Three Mile Island, Unit 1
Facility Operating License No. DPR-50
NRC Docket No. 50-289

Subject: Request for NRC Approval of the Three Mile Island Joint Information Center (JIC)
Relocation from Harrisburg to Coatesville, PA.

Radiological Emergency Plan Annex for Three Mile Island (TMI) Station, EP-AA-1009, Changes

**Proposed Changes to the
Exelon Nuclear Radiological Emergency Plan Annex for Three Mile Island (TMI) Station,
EP-AA-1009, Rev 9a**

FIGURE TMI 2-4: Emergency Public Information Organization

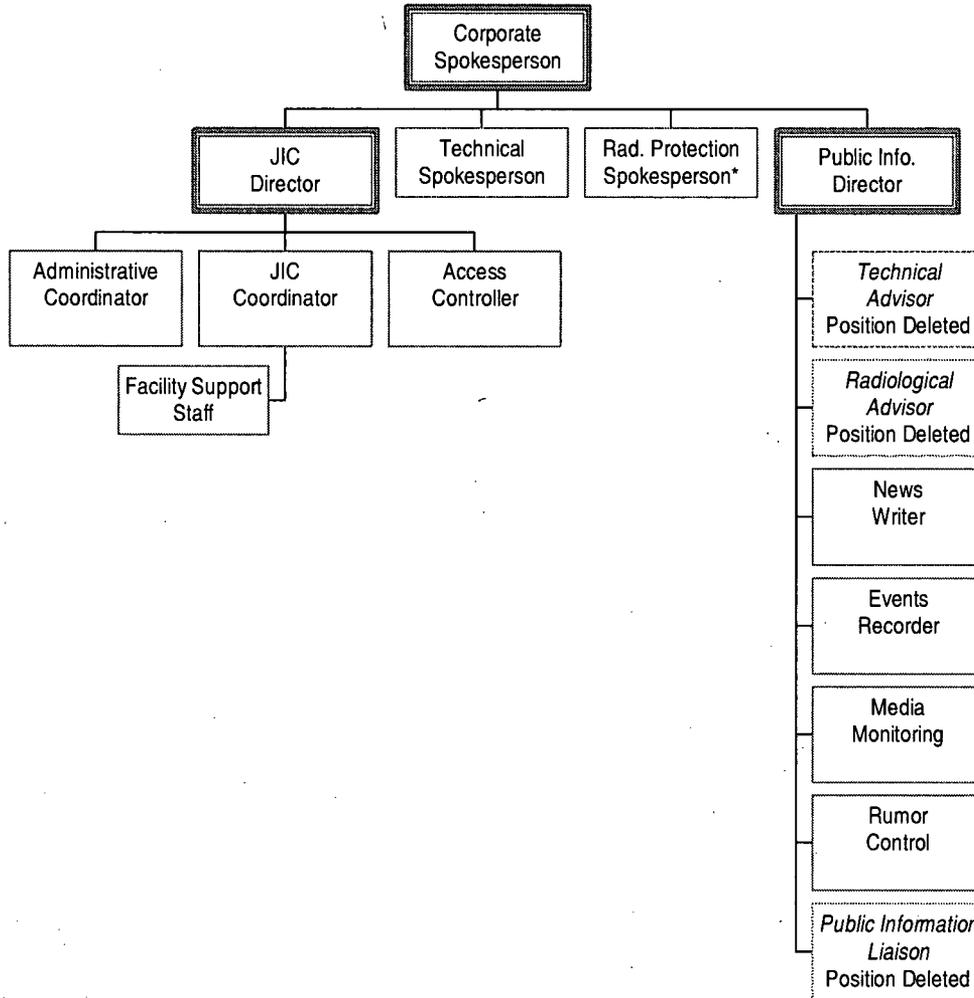
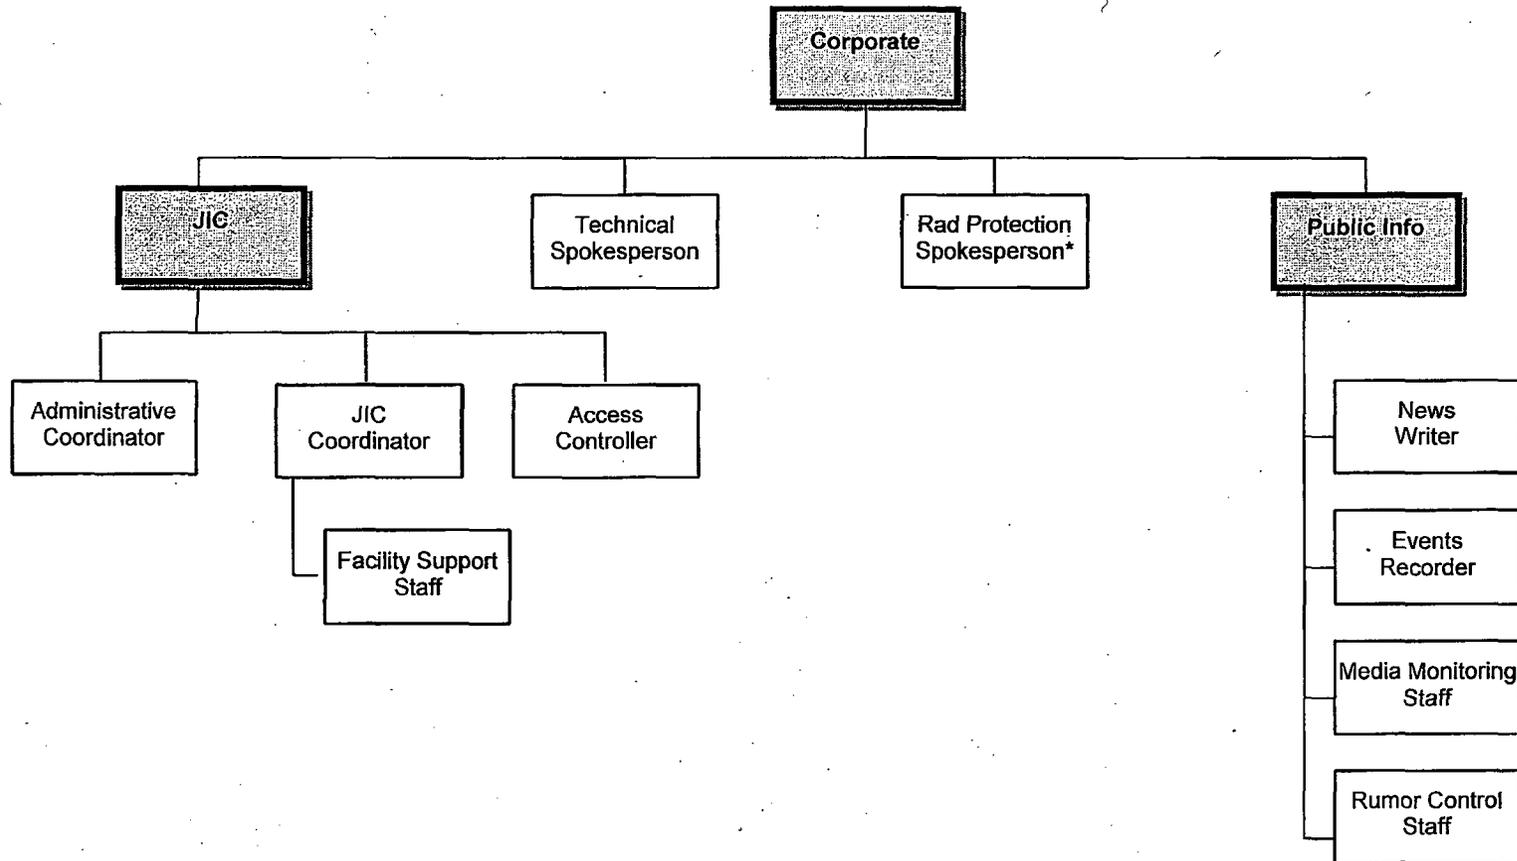
Chg #	Section	Step #	Change Type	Old Wording	New Wording
1.P.	2	2.2.3	<input type="checkbox"/> Added <input type="checkbox"/> Removed <input checked="" type="checkbox"/> Modified	<p>Emergency Public Information Organization (Figure TMI 2-4)</p> <p>Based on the location of the EOF at the Coatesville facility and local siting of the Joint Information Center (JIC) in the Harrisburg, PA areas, no changes in augmentation positions or staffing levels for the JIC exist from that specified in the Standard Plan.</p> <p>For a TMI event, the Public Information Liaison position is assigned to the Emergency News Center (ENC) function at the Coatesville EOF to support the prompt transfer of information and relaying of communications to and from the Harrisburg JIC.</p> <p>For TMI, the JIC facility is separate from the ENC facility and additional ERO positions exist as a result. Below are the position descriptions for the ERO positions in the JIC and ENC.</p>	<p>Emergency Public Information Organization (Figure TMI 2-4)</p> <p>No changes in augmentation positions or staffing levels for the Joint Information Center from that specified in the Standard Plan except that the Radiological Spokesperson may be staffed by a qualified consultant.</p>

18.P.	2	Figure TMI 2-4	<input type="checkbox"/> Added <input type="checkbox"/> Removed <input checked="" type="checkbox"/> Modified	Figure TMI 2-4, Emergency Public Information Organization (See Appendix 2)	Figure TMI 2-4, Emergency Public Information Organization (See Appendix 2)

No changes in augmentation positions or staffing levels for the Joint Information Center from that specified in the Standard Plan except that the Radiological Spokesperson may be staffed by a qualified consultant. ~~Based on the location of the EOF at the Coatesville facility and local siting of the Joint Information Center (JIC) in the Harrisburg, PA areas, no changes in augmentation positions or staffing levels for the JIC exist from that specified in the Standard Plan.~~

Chg #	Impact	Change impacts on the Program Requirements
17.P 18.P	<input type="checkbox"/> No affect <input type="checkbox"/> Enhancement <input checked="" type="checkbox"/> AM <input type="checkbox"/> Degradation	<p>Changes to the Emergency Plan table TMI-2-1 and Figure TMI 2-4 reflect the elimination of the three positions as detailed above, and the consolidation of the EOF and JIC Clerical support (minimum number of clerical is unchanged).</p> <p>The ability to effectively perform the compiled list of tasks has been demonstrated repeatedly at the Limerick and Peach Bottom stations which have been using this model, as approved by the NRC, for an extended period of time.</p> <p>NRC guidance on the 50.54(q) evaluation states that a decrease in effectiveness is determined to have occurred if there has been a change or reduction in a commitment without a commensurate change or reduction in the bases for that commitment. A commitment is defined as a statement made in the Emergency Plan that affects the capability or resources for responding to an emergency.</p> <p>Exelon has concluded that the proposed change will not result in a reduction of the capability of the Emergency Response Organization (ERO) to respond to an emergency, and will not reduce Exelon's ability to protect the health and safety of the public. The consolidation of Exelon's Emergency Response Facilities has been approved by the NRC previously when the EOF's were moved to a common EOF in Coatesville, PA. The elimination of the separate JIC for TMI station is proposed as an alternate method.</p>

FIGURE TMI 4-3: Remote Assembly Area – Former Harrisburg JIC (Commerce Park)

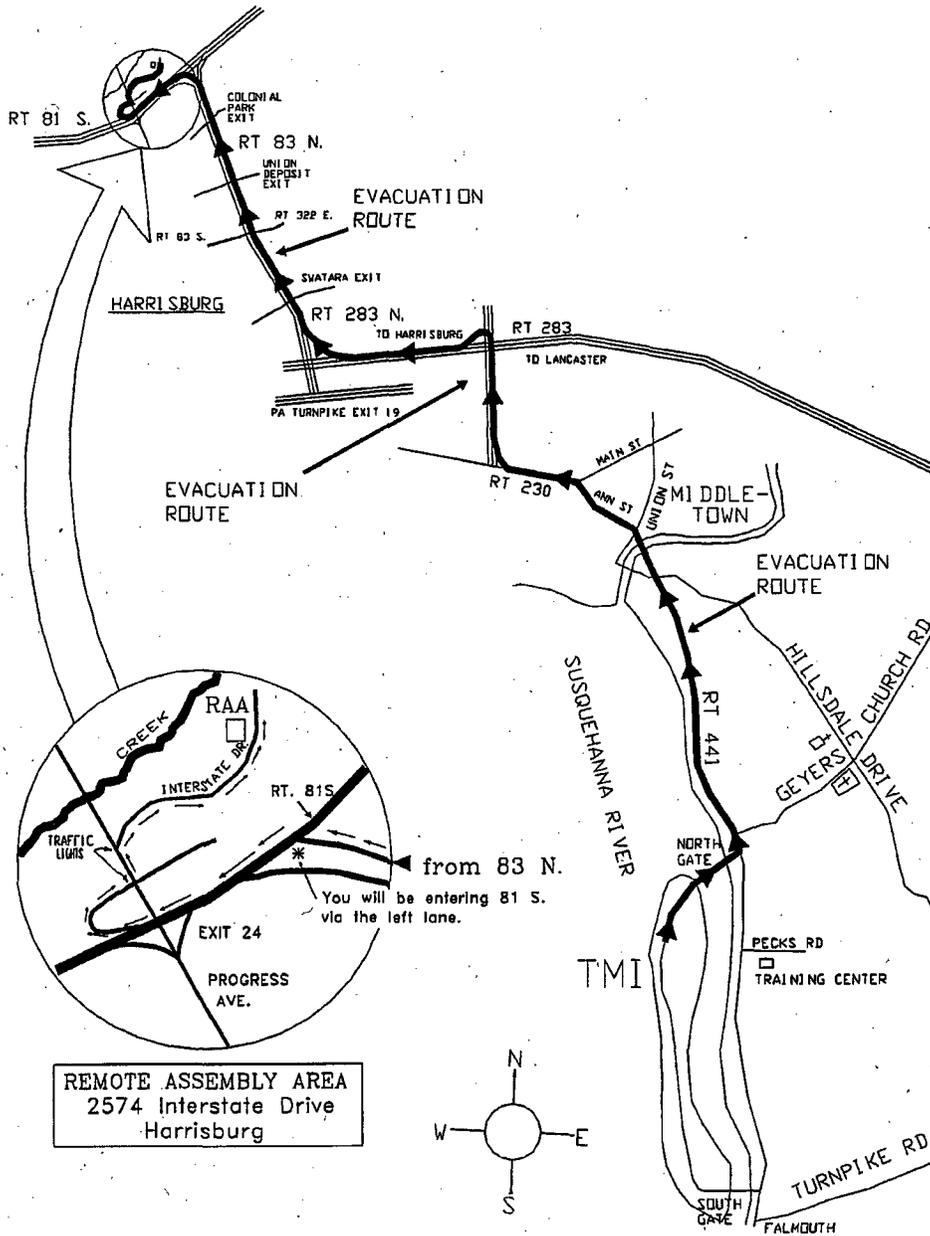
19.P.	4	Figure TMI 4-3 Title	<input type="checkbox"/> Added <input type="checkbox"/> Removed <input checked="" type="checkbox"/> Modified	Figure TMI 4-3 Remote Assembly Area -- Harrisburg JIC (Commerce Park)	Figure TMI 4-3 Remote Assembly Area -- Former Harrisburg JIC (Commerce Park). This also is reflected in the Table of Contents on page ii.
